Access Compliance Report Public Rights-of-Way (Curb Ramps)

Intersection ID: 31885 Main Street: SLALOM_HILL_RD Cross Street: SPRUCE_PEAK_RD Location: NW

ADA ID: 1ACC1A233FC1 Ramp Type: PerpDiag Initial Pass/Fail: Fail Overall Compliance: No Severity Score: 31.25

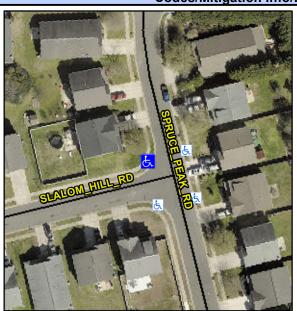
R304.5.1, R304.2.2, R304.5.3

Compliance Description		Data	Compliance Description		Data
N/A	Ramp Length (in)	47.0	No	Ramp Slope (%)	10.3
No	Ramp Width (in)	34.0	No	Ramp XSlope (%)	3.9
N/A	Flare Type LT	N/A	N/A	Flare Type RT	N/A
N/A	Flare Slope LT (%)	N/A	N/A	Flare Slope RT (%)	N/A
N/A	Flare Traversable LT?	N/A	N/A	Flare Traversable RT?	N/A
N/A	Landing Length (in)	N/A	N/A	DWS Provided?	N/A
N/A	Landing Width (in)	N/A	N/A	DWS Contrast?	N/A
N/A	Landing Slope (%)	N/A	N/A	DWS Length (in)	N/A
N/A	Landing X Slope (%)	N/A	N/A	DWS Full Width?	N/A
N/A	Landing Curb? (Y/N)	N/A	N/A	DWS Offset (in)	N/A
N/A	Shared Landing?	N/A			
N/A	Gutter Ponding?	N/A	N/A	Gutter Slope (%)	N/A
N/A	Gutter Lip Ht (in)	N/A	N/A	Gutter X Slope (%)	N/A
N/A	Painted X Walk1?	No	N/A	Painted X Walk2?	No
	X Walk 1 Direction	To S		X Walk 2 Direction	ТоЕ
N/A	X Walk 1 Width (in)	N/A	N/A	X Walk 2 Width (in)	N/A
	X Walk 1 Slope (%)	1.3		X Walk 2 Slope (%)	5.9
	X Walk 1 X Slope (%)	3.8		X Walk 2 X Slope (%)	0.3

Remove & Replace Curb Ramp With Two New Directional Ramps or Equivalent.
